Docket Item # 7
BAR CASE #2006-0023

BAR Meeting
May 17, 2006

ISSUE: Addition
APPLICANT: Ann Sennewald
LOCATION: 326 South Pitt Street
ZONE: RM/Residential

Figure 1 Proposed rear elevation

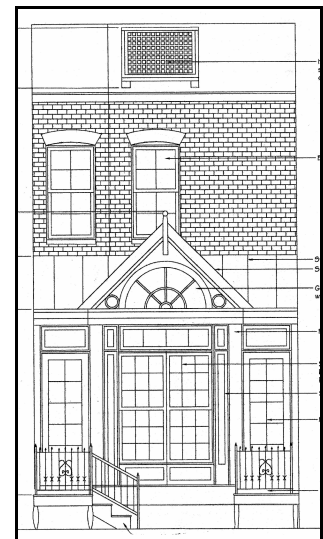
326 South Pitt Street has modest late Victorian detailing on the front facade, with later alterations to the front door and windows . In staff's opinion, the proposed new sunroom is compatible to the historic structure, but is distinguishable as new due to its styling as a conservatory. Despite being slightly larger than the existing sunroom addition, the proposed addition is still smaller in scale with the historic building. Its one-story height helps mitigate its visual impact on the historic building. While colors were not discussed in the applicant's submittal, staff would encourage the addition's colors, both the wood trim and the color of the standing seam roof, to be compatible and blend with the existing colors of the historic house, as well as adjacent properties. With a consideration of colors by the applicant, staff can support the addition and recommend approval.

However, staff is concerned about the relocation of the HVAC unit to the roof the historic ell and the lattice screening. As shown, the HVAC unit and its screening will be highly visible from Wolfe Street. Staff would encourage the applicant to explore other options for the location of the HVAC unit and would recommend deferring this component for restudy.

The design of the addition seems incompatible with the simplicity of the neighboring homes. Also, the HVAC unit on the roof would be prominently visible, even with screening.

Staff recommends approval of the proposed addition and deferral for restudy of the HVAC unit relocation and screening.
